CHURCH OF THE MAGDALEN ADDITION

WICHITA, SEDGWICK COUNTY, KANSAS

RE: SUB 2000-24 -- **REVISED** Final Plat of CHURCH OF THE MAGDALEN ADDITION

RE: SUB 2000-24 -- Final Plat of CHURCH OF THE MAGDALEN ADDITION

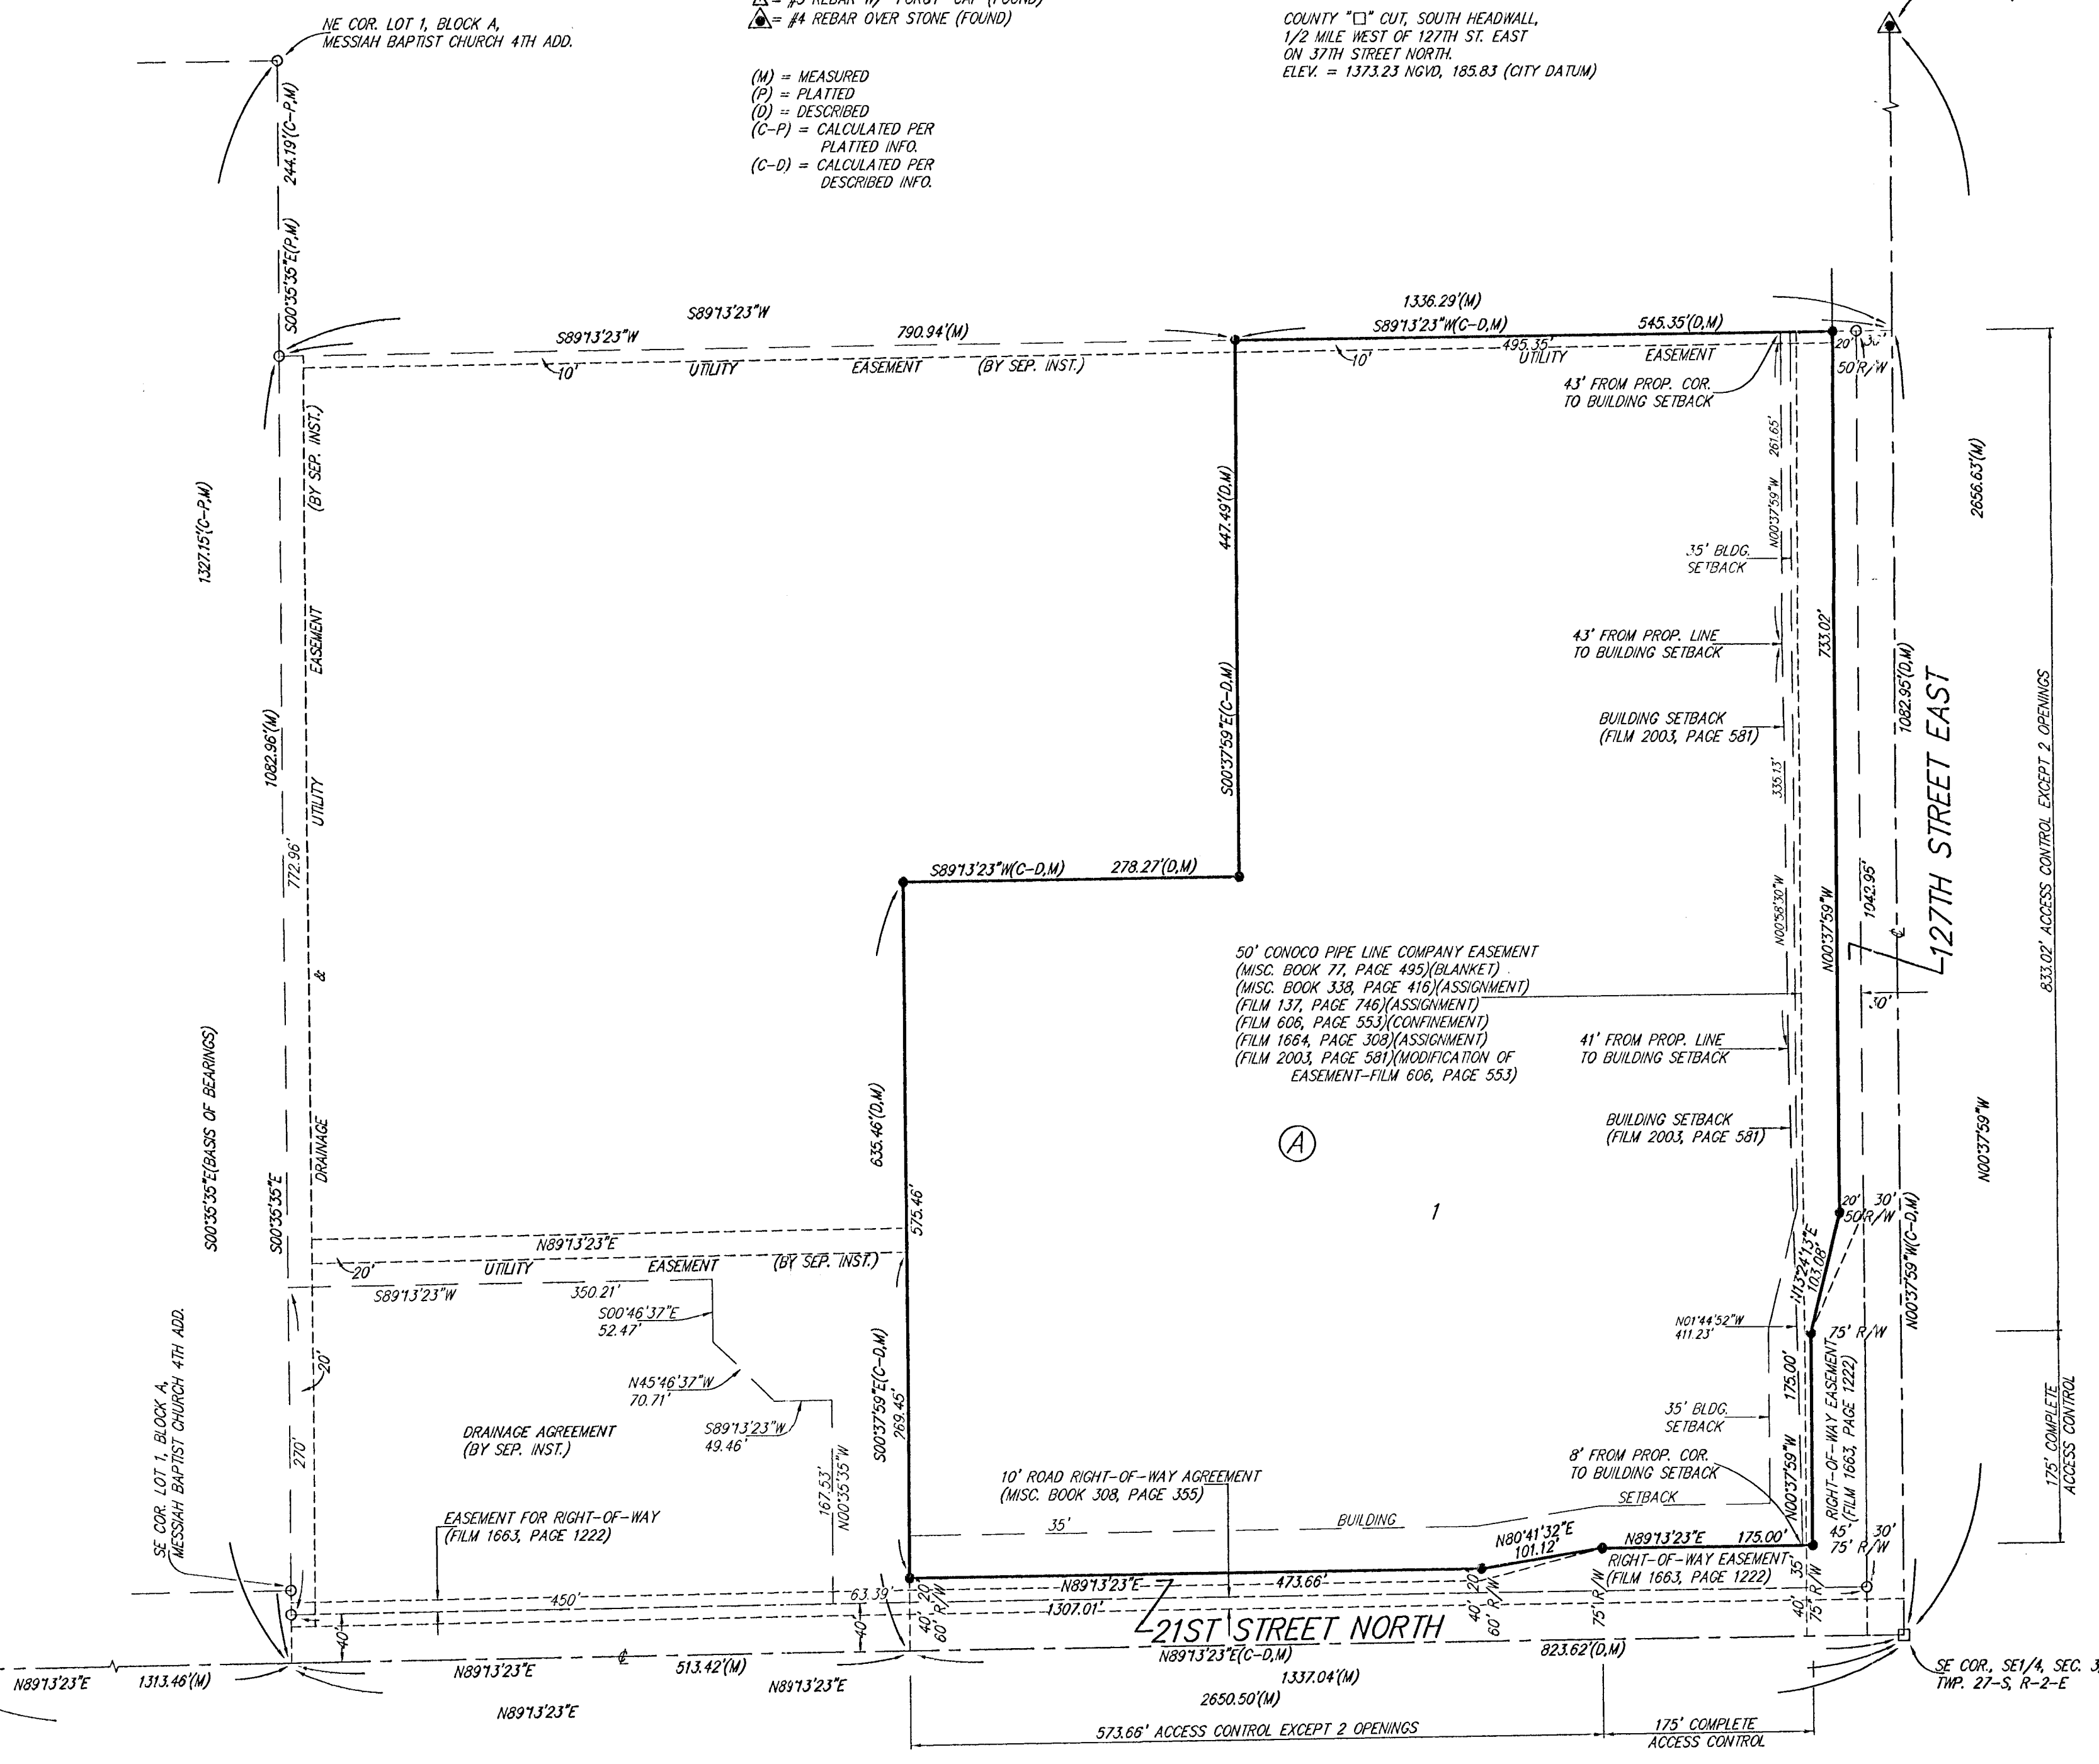
- D. **City/County Engineering** needs to comment on the status of the applicant's drainage plan. *County Engineering has required a copy of the final drainage plan to verify how off-site drainage is to be handled. City Engineering has approved the drainage plan and has required a cross-lot drainage easement. The minimum building elevation appears to be too low.*

- J. In the plat^{or}'s text, the word "Reserve" shall be corrected.
- K. The 35' building setback lines along the tapers on the road rights-of-way need to be parallel with the new property lines.

- L. The 35' building setback along 127th Street needs increased to include the pipeline setback with a definite dimension with respect to the plat.
- M. For those reserves being platted for drainage purposes, the required covenant which provides for ownership and maintenance of the reserves shall grant, to the City, the authority to maintain the drainage reserves in the event the owner(s) fail to do so. The covenant shall provide for the cost of such maintenance to be charged back to the owner(s) by the governing body.
